Certificate of Appropriateness

Property	2006 E. LAFAYETTE PL.	North Point South HD
Description of work	See attached drawings	
8 pages total	<p>The Residence is located on a small corner lot with limited yard & no private outdoor space. The proposed work is to add a Rooftop Terrace above an existing flat roof garage structure to add private yard space to the property.</p> <p>We are proposing to replace the existing sliding overhead doors off of Summit Avenue and single overhead door off the alley. The new overhead doors will have a similar design to the existing sliding overhead doors and be painted cedar to match existing trim. The Summit Avenue door will be 9' high by 18' wide and the alley door will be 9' high by 9' wide. We are proposing to replace the existing rear door adjacent to the Summit Avenue overhead door. The new door will be similar to existing side door at stoop off Summit Avenue and include a new transom similar to divided lights at overhead doors.</p> <p>We are proposing to add new wood windows to match previously approved window replacement at First, Second, & Third Floors. The new windows will be at existing window openings at the Garage & Lower Level. We are pr

A4.2

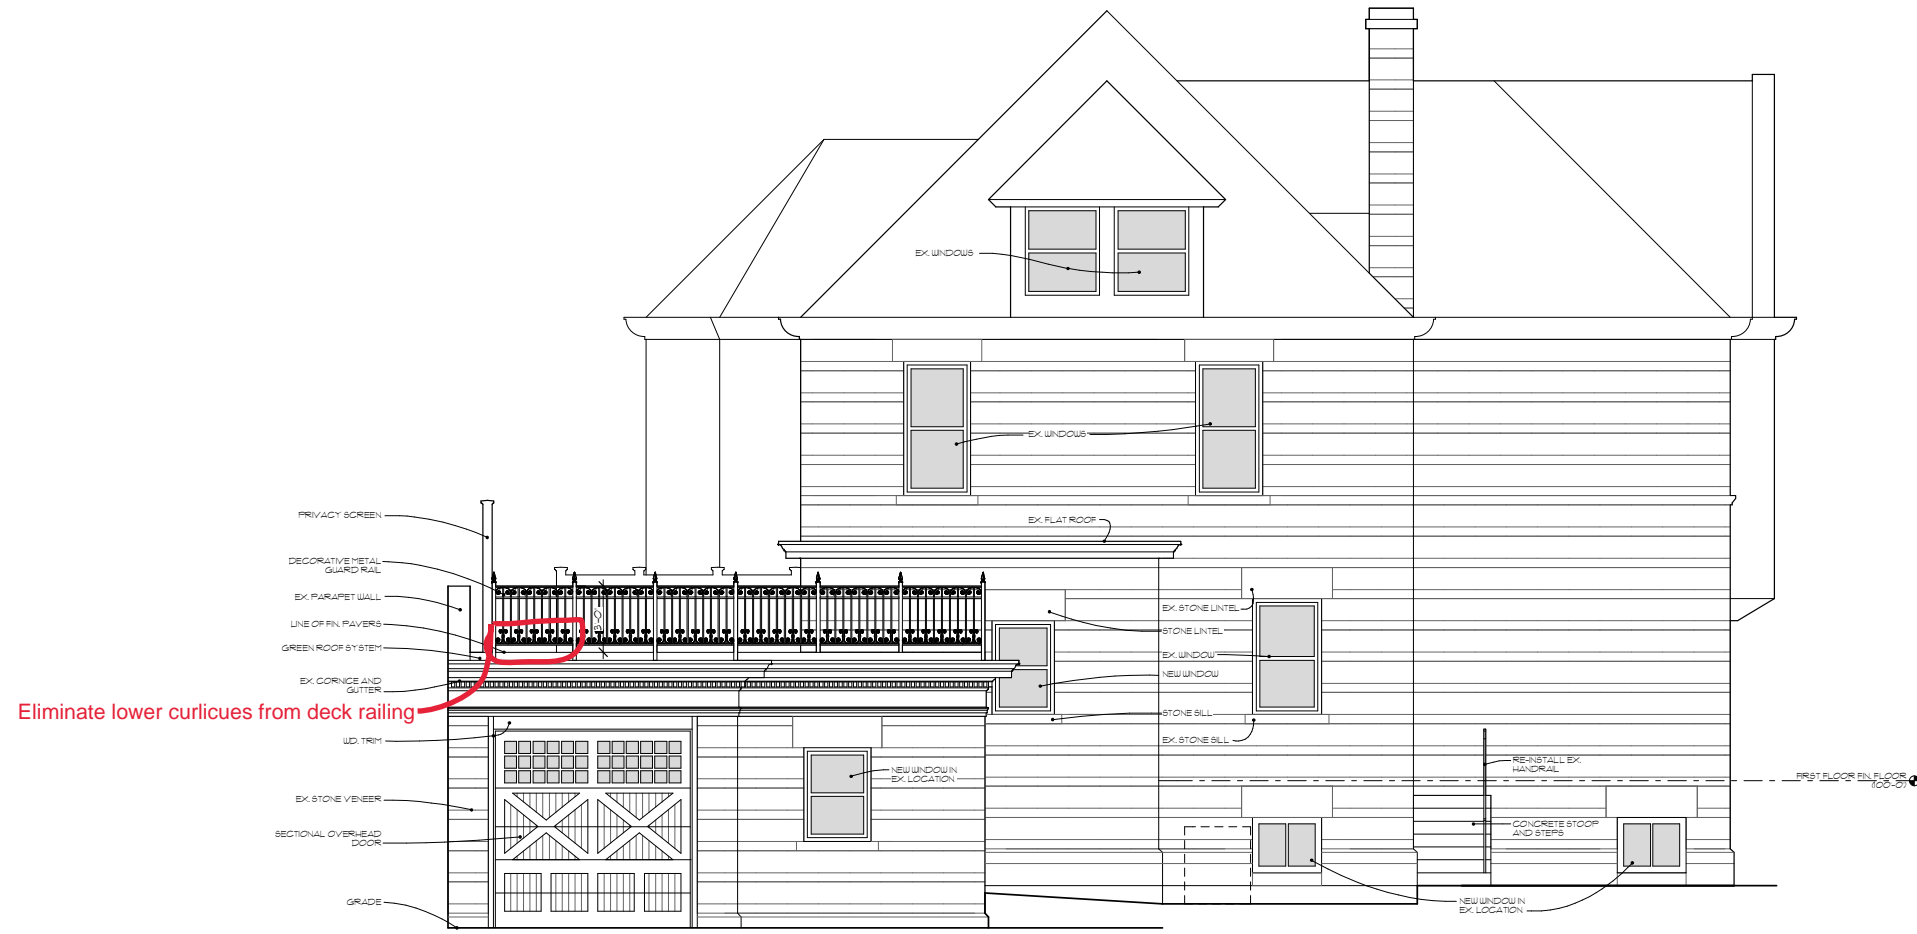
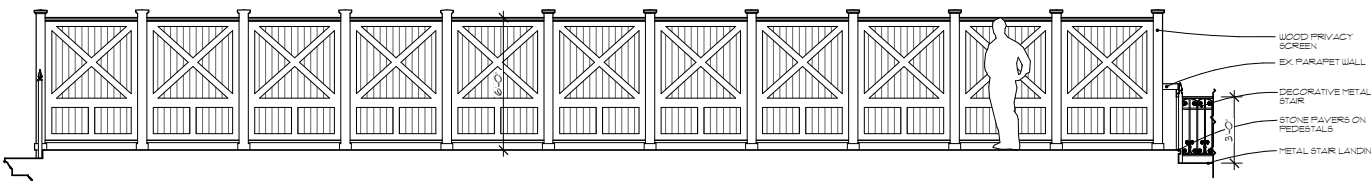
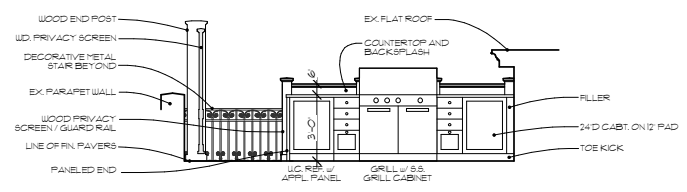
Bottom row of curlicues shall be removed from the design of the metal railing on garage roof. The Bottom row of curlicues may be removed from railings elsewhere.

Eliminate lower curlicues from deck railing
